UNITED STATES PATENT AND TRADEMARK OFFICE

10/562,681

Office Action Summary	Application No. 10/562,681	Applicant(s) ANDOH ET AL.	
	Examiner DAVID C. MELLON	Art Unit 1797

DETAILED ACTION

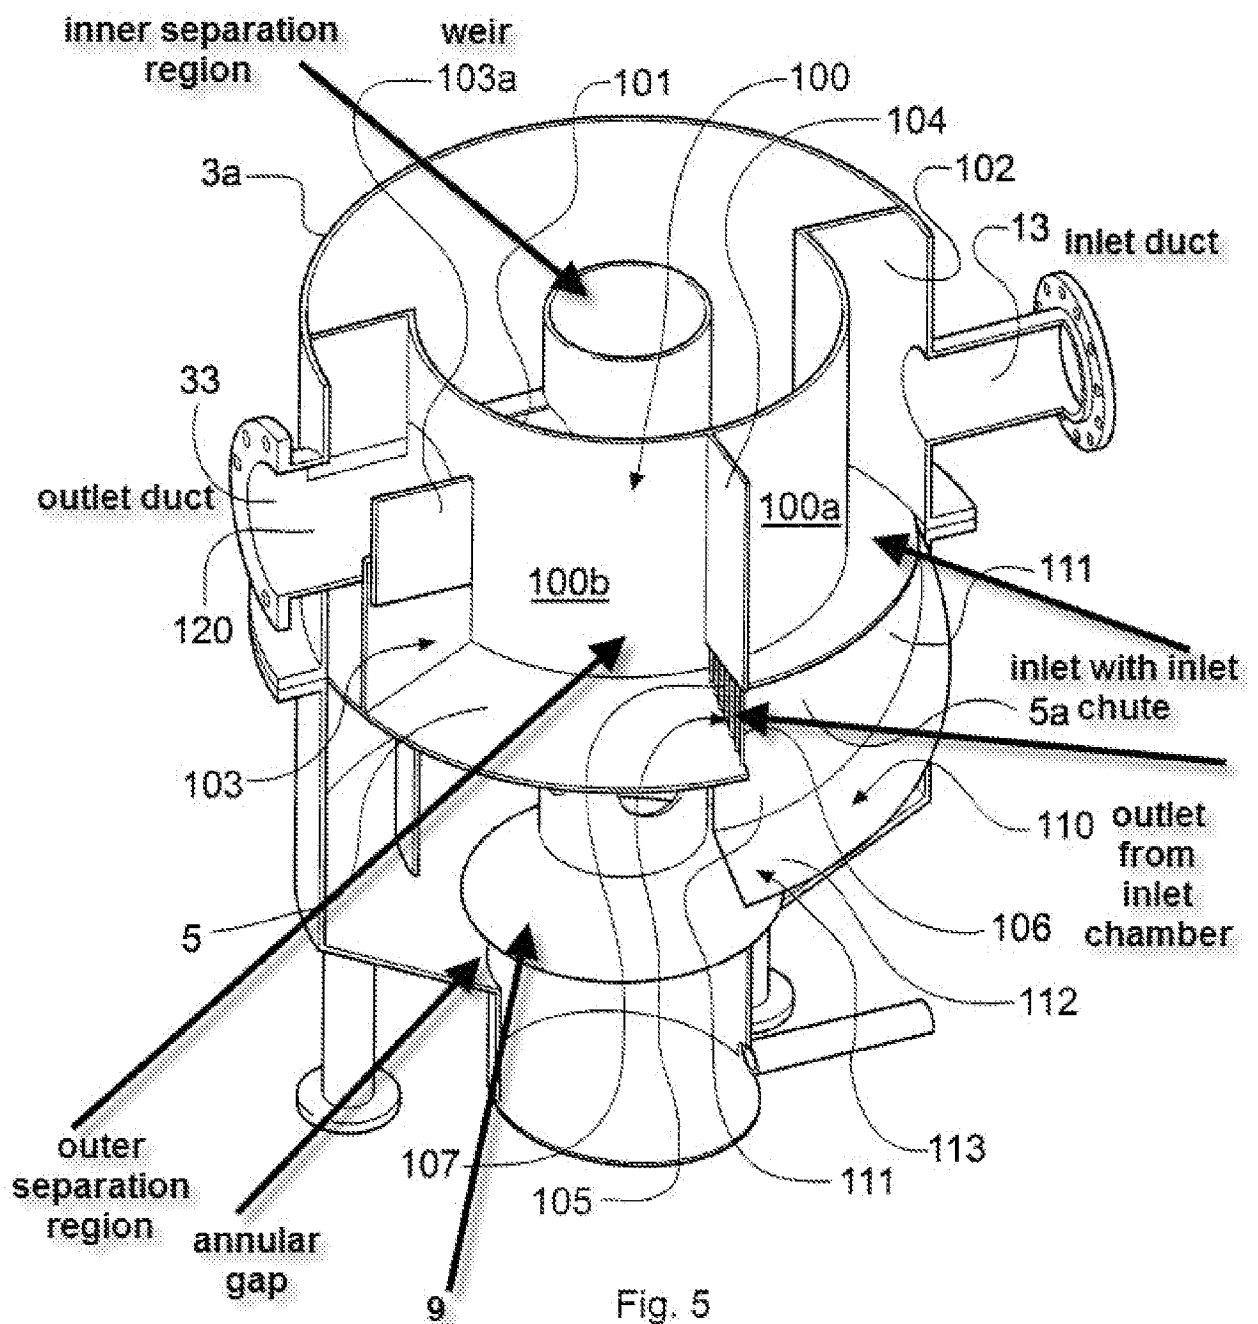
Regarding claims 1-2, Andoh et al. discloses a hydrodynamic separator for separating material from a liquid (abstract) in figures 1, 4-6 comprising:

- A vessel (2) having a cylindrical outer wall (3)

- An inner partition (chamber – 31)
- An inlet (13) opening into the outer separation region (see annotated figure 5)
- An outlet (33) opening into the inner separation region (see annotated figure 5)
- A frustoconical base (9) which converges to a downward outlet opening (8a).

Regarding claim 12, Andoh et al. further discloses that the wall (9) terminates short of the frustoconical base of the vessel, creating a gap between the base and the wall (see annotated figure 5).

Regarding claims 16 and 17, Andoh et al. further discloses an outlet duct that extends from the liquid outlet through the outer wall of the vessel and is inline with the inlet duct which extends through the outer wall (see annotated figure 5, inlet and outlet 13 and 33 extending through vessel wall and inline with one another).

Regarding claim 18, Andoh et al. further discloses an inlet disposed below the inlet duct (see annotated figure 5) with an inlet port to discharge inlet flow into the vessel in a tangential direction to the cylindrical outer wall (inlet chute is wrapped around the cylindrical wall).

Regarding claim 19, Andoh et al. further discloses that the inlet and outlet ducts are disposed at an upper region of the vessel (see figure 5).

Regarding claims 23 and 24, Andoh et al. further discloses that the inner partition (31) is cylindrical (shown in annotated figure 5) and that the inner partition is coaxial with the outer wall (see figure 4).
